**Final  
Environmental Impact Report**  
for the

# *Hatchet Ridge Wind Project*

June 2008

**Shasta County Department of Resource Management**

HATCHET RIDGE WIND FARM  
PG&E's conceptual switching station siting

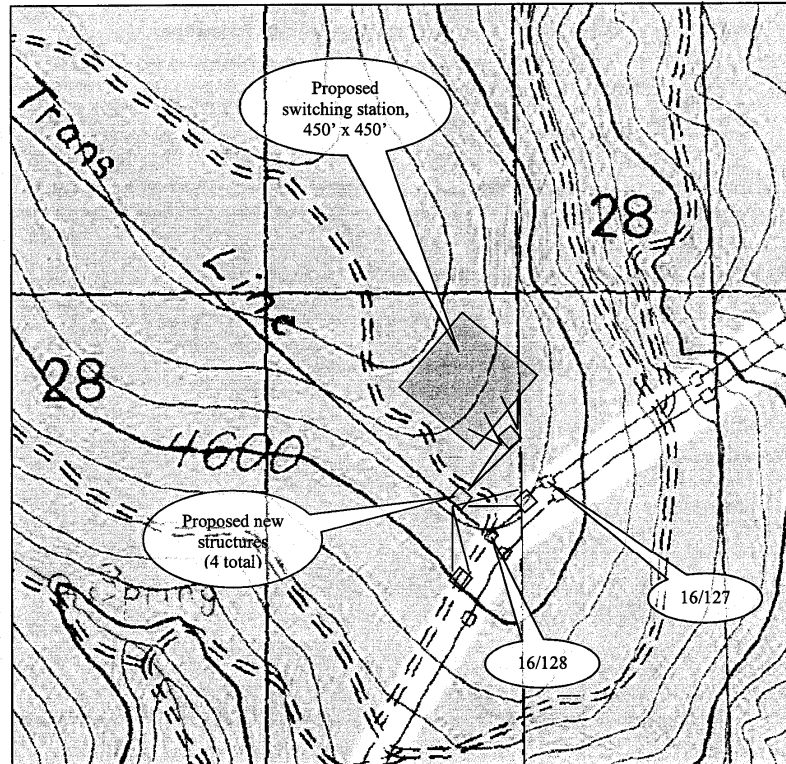
It is acknowledged that the figure does not reflect the locations of either the electrical connector system or the interconnection switching station. Because the electrical connector system would be installed underground in association with new and existing access roads, there would be little utility in modifying the layout graphic (Figure 2-1 in the Draft EIR) to show that component. However, the figure has been revised to show the location of the interconnection switching station. Because the proposed location is at the southern end of the project area at the junction of two existing PG&E transmission lines in an area already subject to vegetation management practices, there would be no impact on sensitive plant species. Subsequent to issuance of the Draft EIR, PG&E commented that the size of the switching station was not 2 acres as indicated in Chapter 2, *Project Description*, but 4.6 acres. The increased size of the switching station would result in the loss of an additional 2.6 acres of habitat that could support special-status wildlife species. This effect is addressed in Impact BIO-3. The addition of 2.6 acres to the 73 acres already identified would not increase the level of significance of this impact; however, the text in Section 3.4 has been revised to reflect inclusion of the switching station.

**Figure 2-1**  
**Representative Configuration of the**  
**Proposed Hatched Ridge Wind Project**

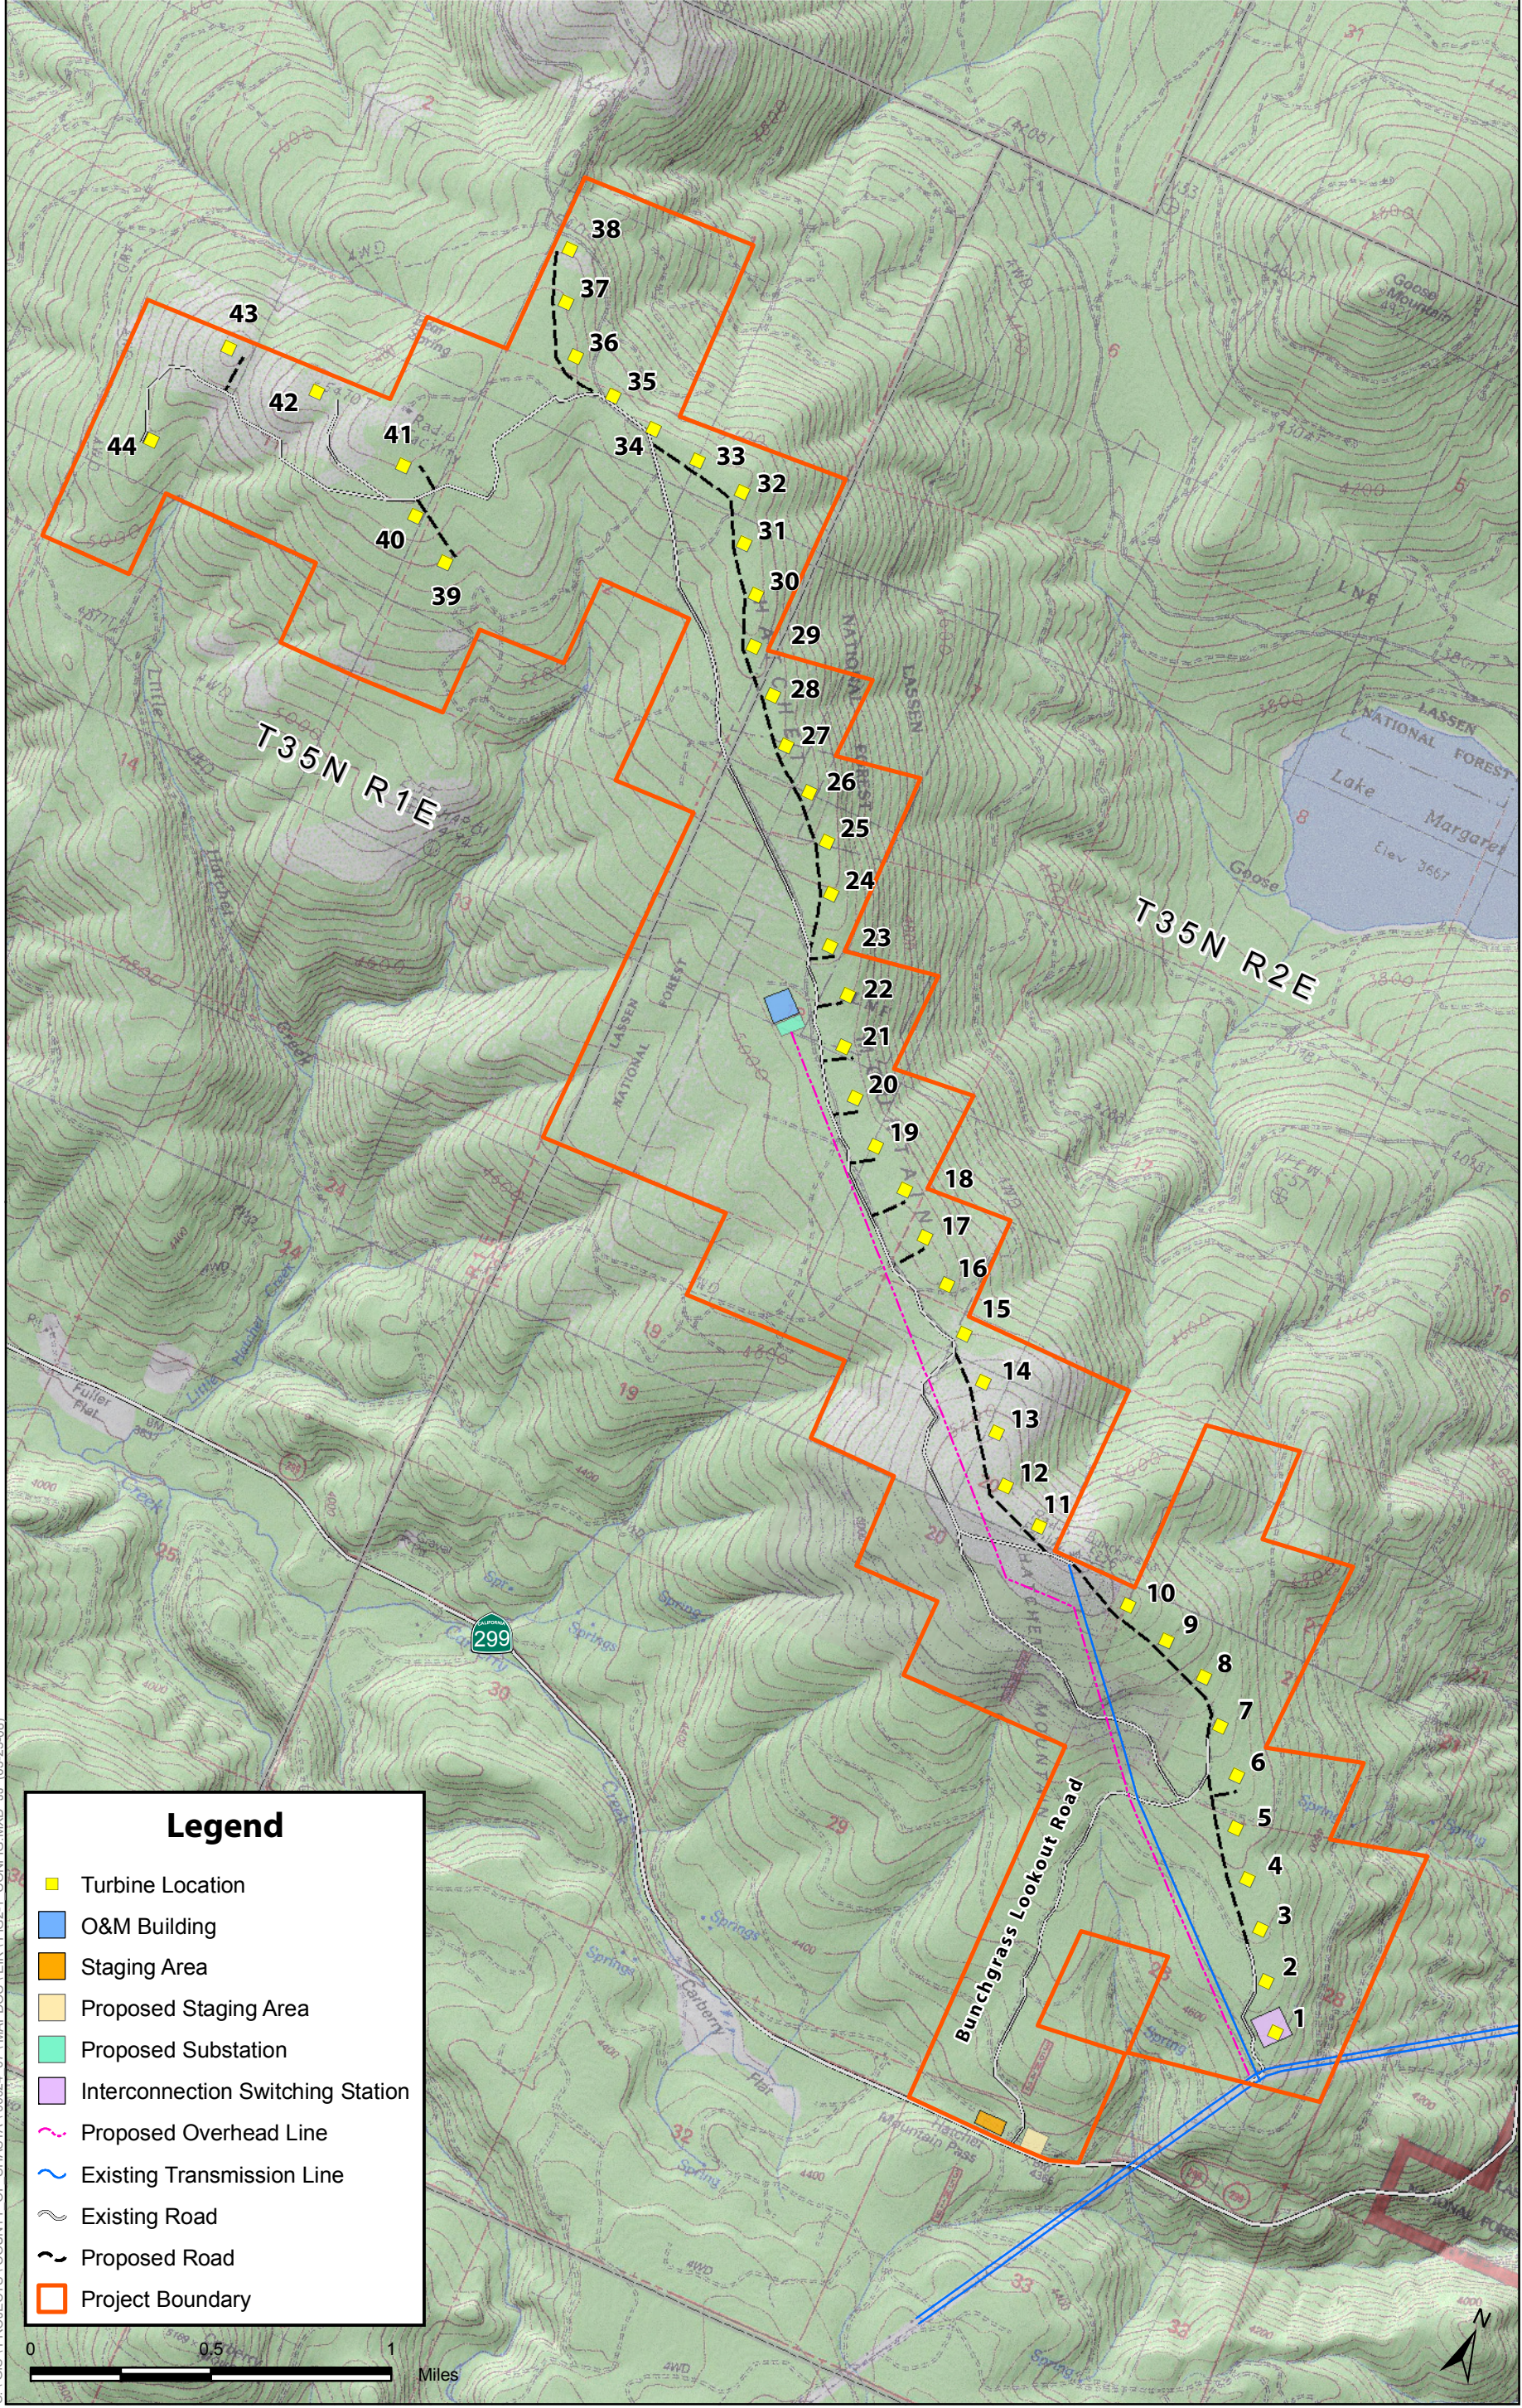
| <p>5. It is unclear which of the proposed roads are to be permanent and which are to be temporary. Are all of the proposed roads delineated on figure 2-1 permanent?</p>   | <p>PA2-6</p>  |
| <p>6. Are the temporary (136 acres) and permanent (73 acres) calculated using the 44 turbine locations mapped on figure 2-1 or the 68 potential locations? Additionally is the total area of the footings calculated using the pier-type footings (256 square feet) or the spread footing foundations (1600 square feet)?</p>  | <p>PA2-7</p>  |

Because the locations of the meteorological towers have not been finalized, it was not possible to depict those locations on the project configuration graphic (Figure 2-1 in the Draft EIR), nor to include them in the visual simulations prepared for the proposed project. However, because there would be only two permanent towers, because all the towers would be considerably smaller than the wind turbines (220 feet contrasted with more than 400 feet) and would have no moving parts, and because the visual impact has already been determined to be significant and unavoidable, revising the figures would add no meaningful substance to the analysis.

Revisions to the text of the draft EIR are presented in this chapter. Changes are referenced by chapter and page number as the original text appeared in the draft EIR. One figure (Figure 2-1) has also been revised, and is included here. Table 3.4-3 has been revised; it is included in its entirety. The figure and the table appear at the end of this chapter. Revisions are shown in strikeout/underline format. These changes, in concert with the unrevised text of the draft EIR, constitute the final EIR.

development corridor boundaries as shown in Figure 2-1; the final permanent project footprint of the Hatchet Ridge Wind Energy project would be approximately ~~73~~75.6 acres.

**Figure 1.** View looking West from Burney (current proposed MWT95 2.4 MW Layout)

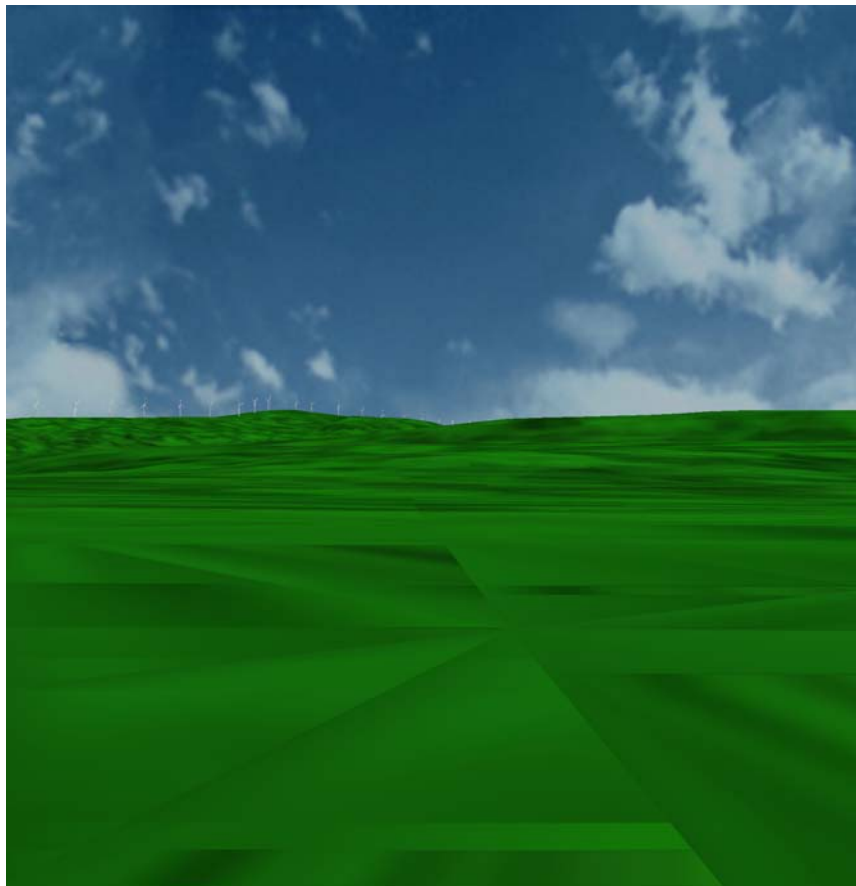
Per the request of Shasta County for the Project Applicant of the Hatchet Ridge Wind Project to come up with a site plan that would eliminate views of the Project from the town of Burney, Babcock and Brown, LP meteorological and technical team (B&B) has; 1) investigated the zone of visual influence (ZVI) for the town of Burney, CA using the proposed Hatchet Ridge Project turbine layout and 2) calculated the production that would occur from relocating the turbines. Based upon the proposed site plan of forty three 2.4 MW MHI turbines mounted on 80 meter towers, as shown on Figure 1, many of the turbines are visible on the ridgeline when viewed from the Burney area looking west.

**Hatchet Ridge Project: Current Proposed and No Zone of Visual Influence from Burney Layout**

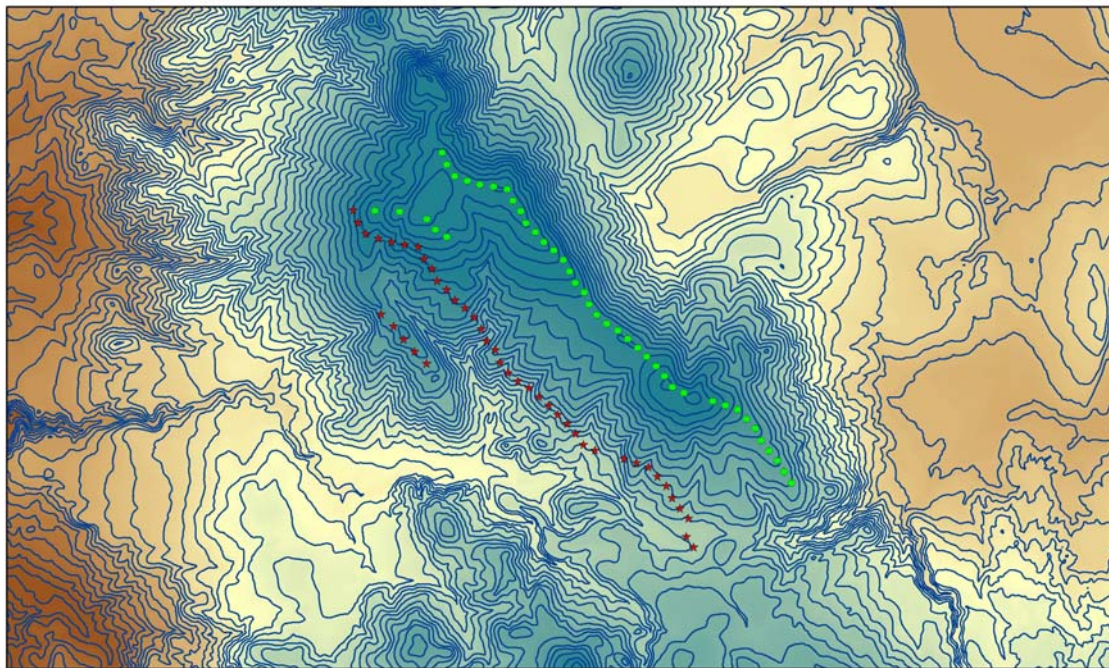
To remove the turbines from the Burney area zone of visual influence, B&B performed a ZVI turbine location analysis that would eliminate all views of turbines from Burney. To achieve this goal, all turbines would have to be moved southwest approximately one mile and off the main ridgeline. Figure 2 shows a map of the current proposed layout (green dots), and the new layout with the turbines off the ridgeline and longer visible from Burney (red stars).

There are at least three issues associated with moving the turbines to this new location. They include; 1) the wind resource and resulting energy production at the new location, 2) constructability of the new area and, 3) environmental and/or property setback issues. This report is not qualified to comment on environmental or property
